HISTORIC LANDMARK COMMISSION
STAFF REPORT

Terrace Falls Sun Deck
PLNHLC2014-00576 & PLNHLC2014-00823
171 East 3rd Avenue
December 4, 2014

West Elevation

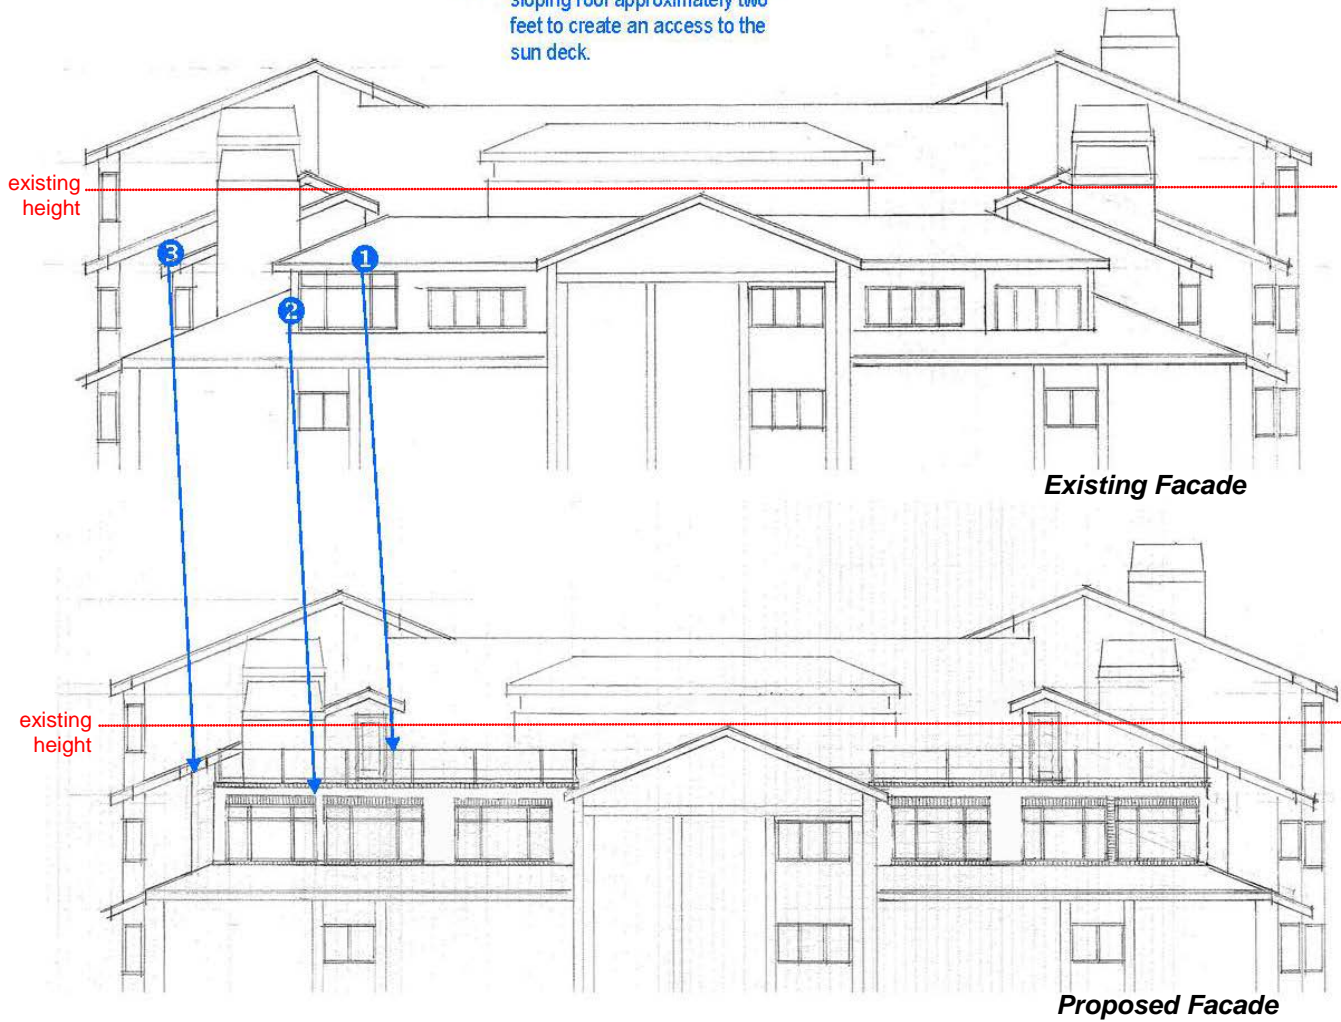
- 1 Changing a sloping roof into a flat roof on the west elevation in order to accommodate a deck.
- 2 Extending the north/south walls to create additional room on the northwest and southwest corners of the building.
- 3 Extending the northerly/southerly sloping roof approximately two feet to create an access to the sun deck.

WEST ELEVATION (PROPOSED)

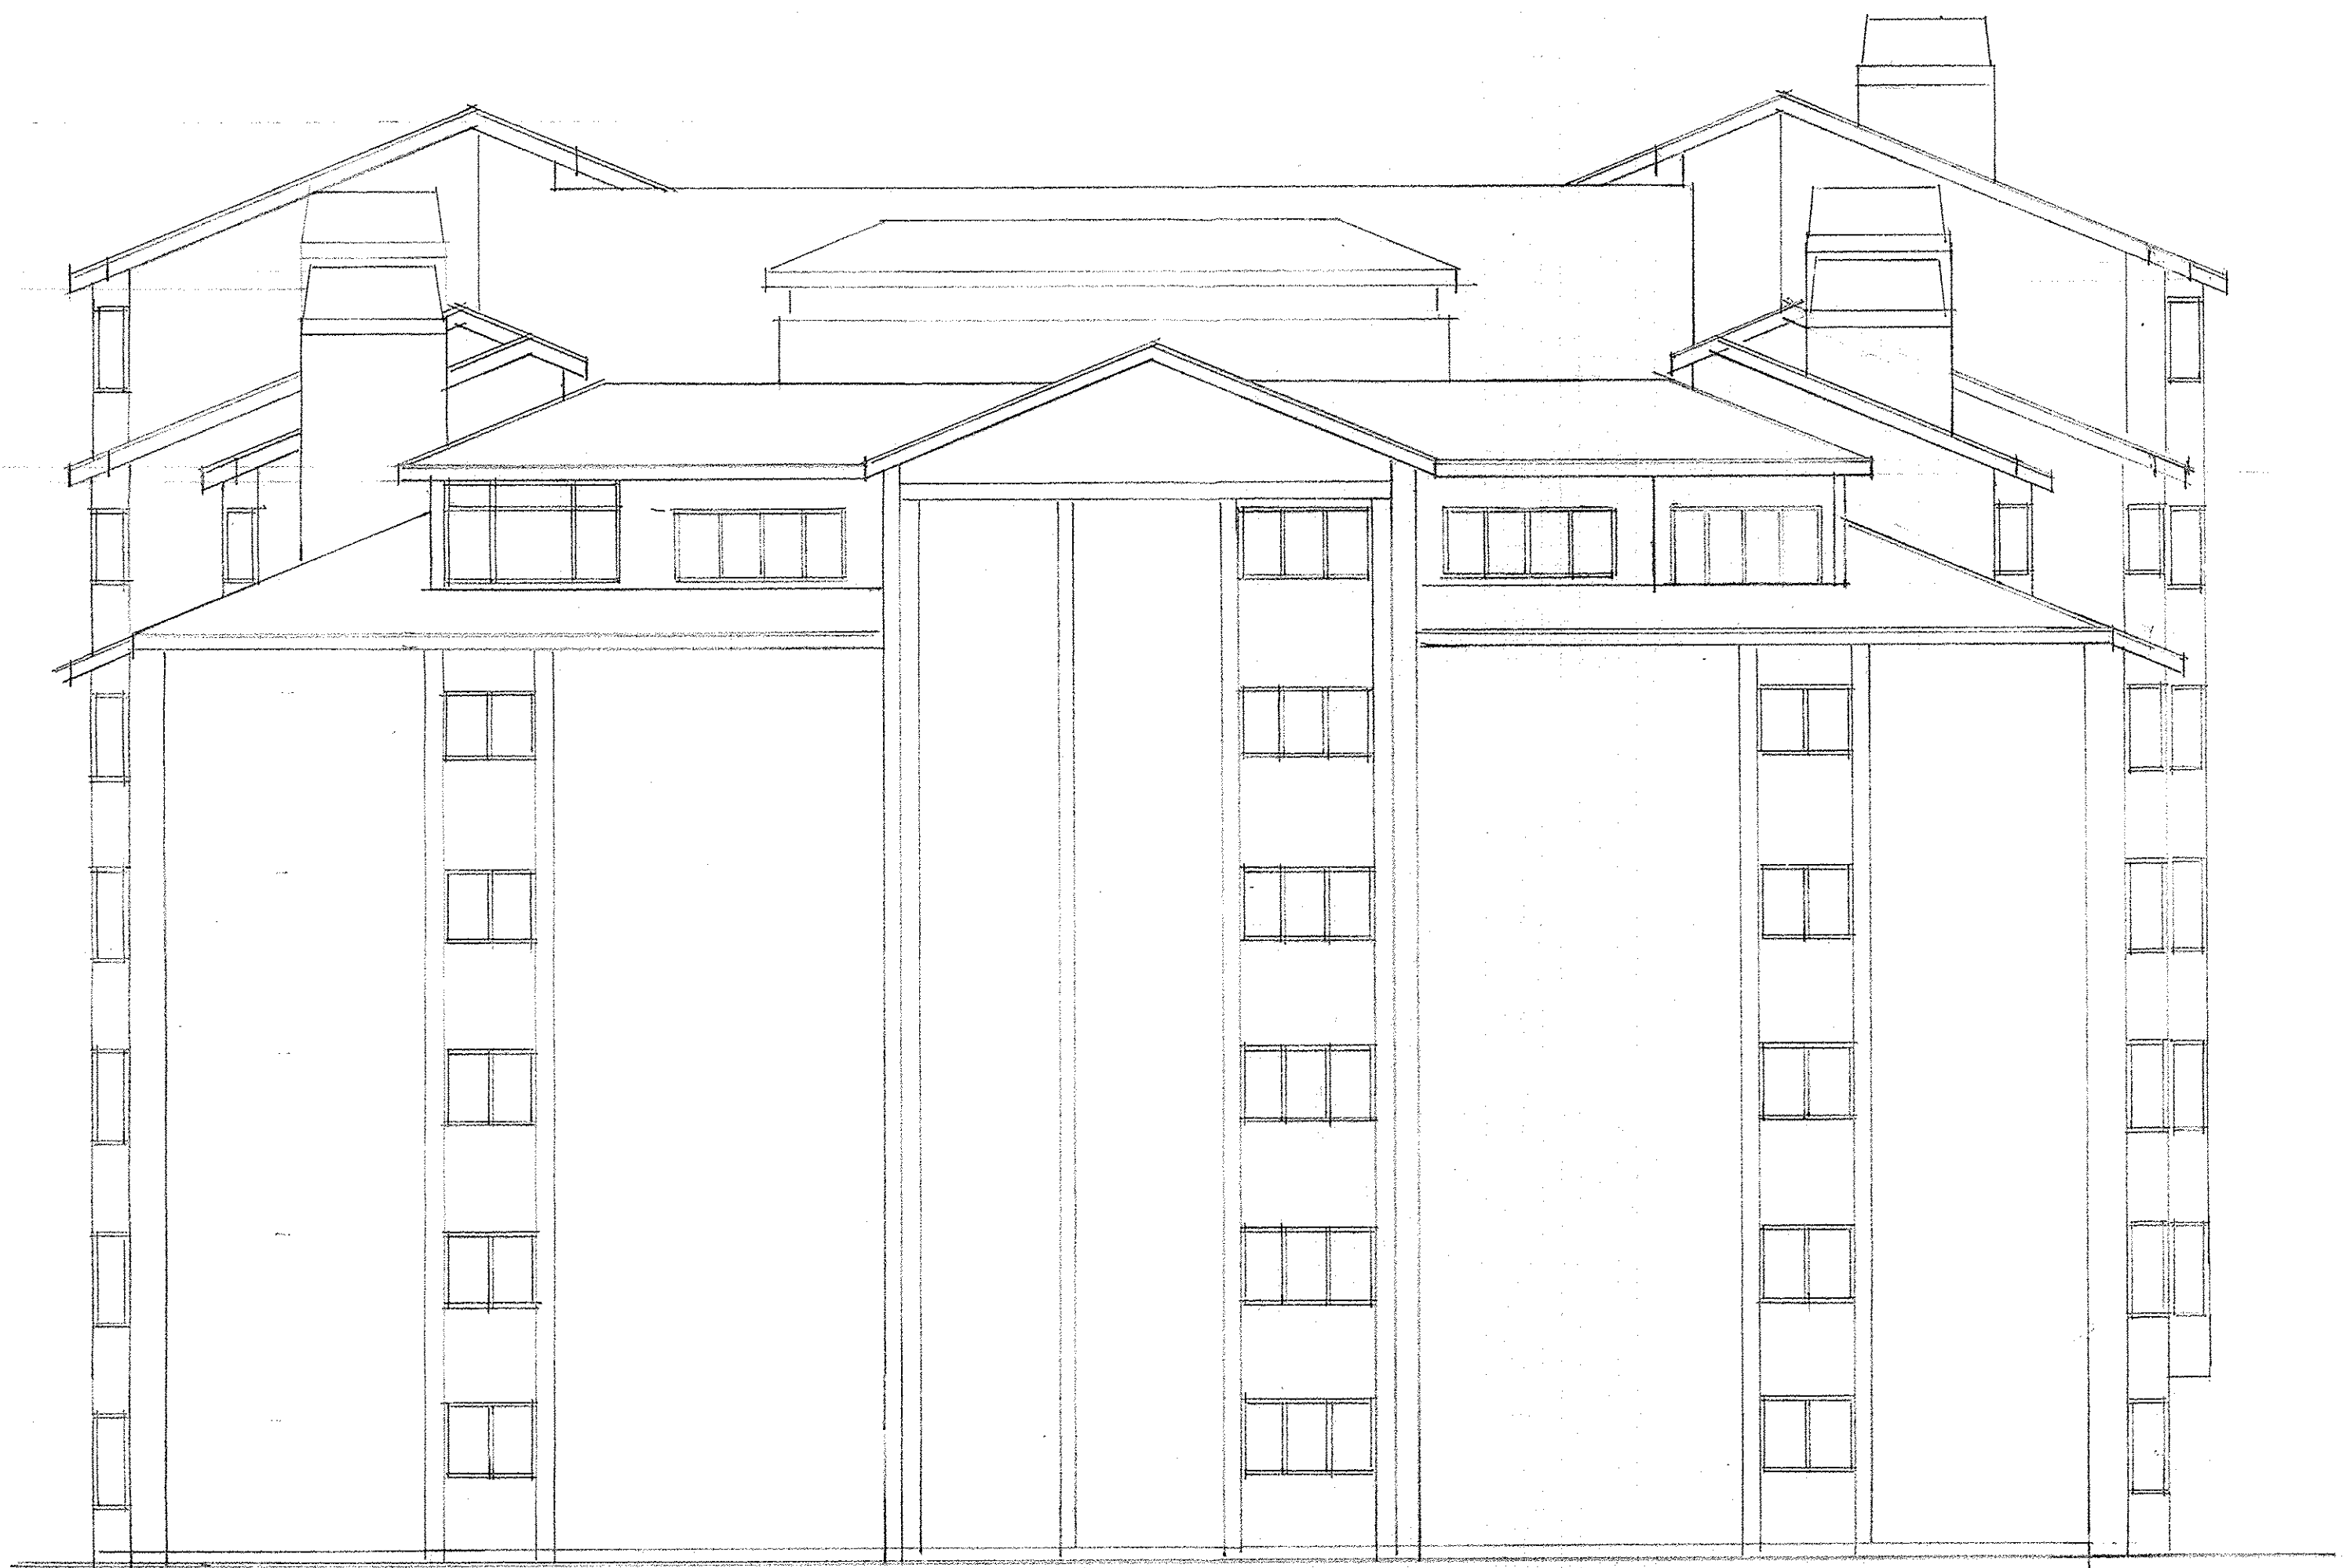
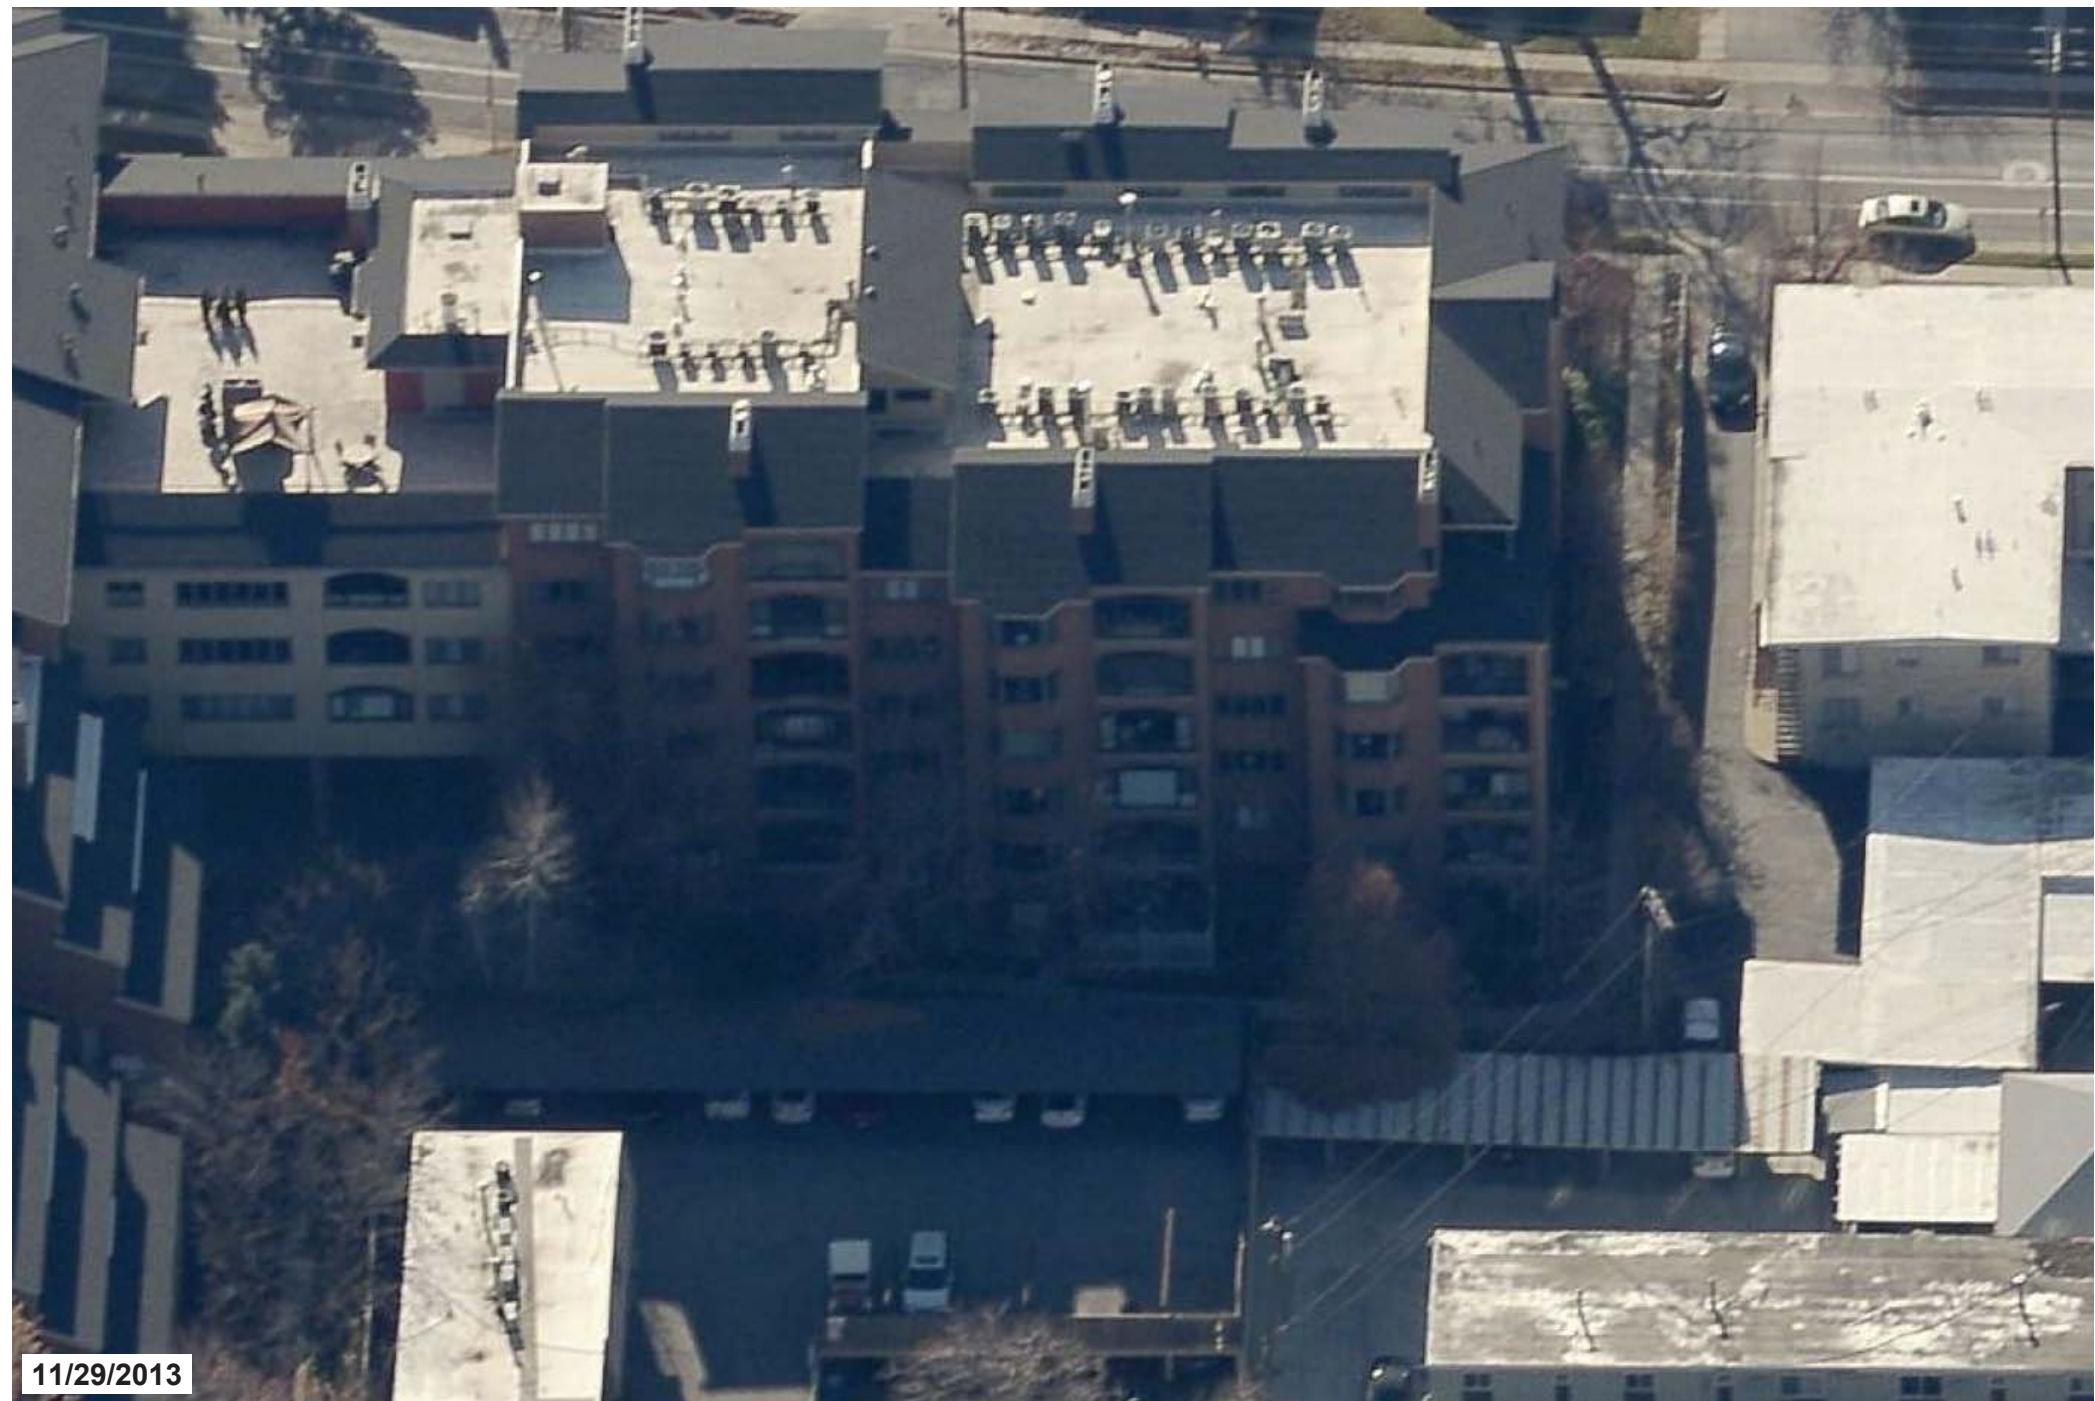
Analysis: The architectural symmetry in this building is important and will be preserved by having both north and south penthouses be changed simultaneously. Additionally, the proposed windows will reflect the characteristic window patterns of the existing architecture. Staff suggested that the current bay windows on the north and south elevations should be replaced with similar bay windows that reflect the proportions of the bay windows below. The applicant has agreed with staff's suggestion.

Finding: A condition of approval should be that the proposed windows on the north and south elevations should be replaced with similar bay windows that reflect the proportions of the bay windows below. Staff finds that the proposal meets the standard. The proposal strives to respect, reflect and also compliment the character of the building.
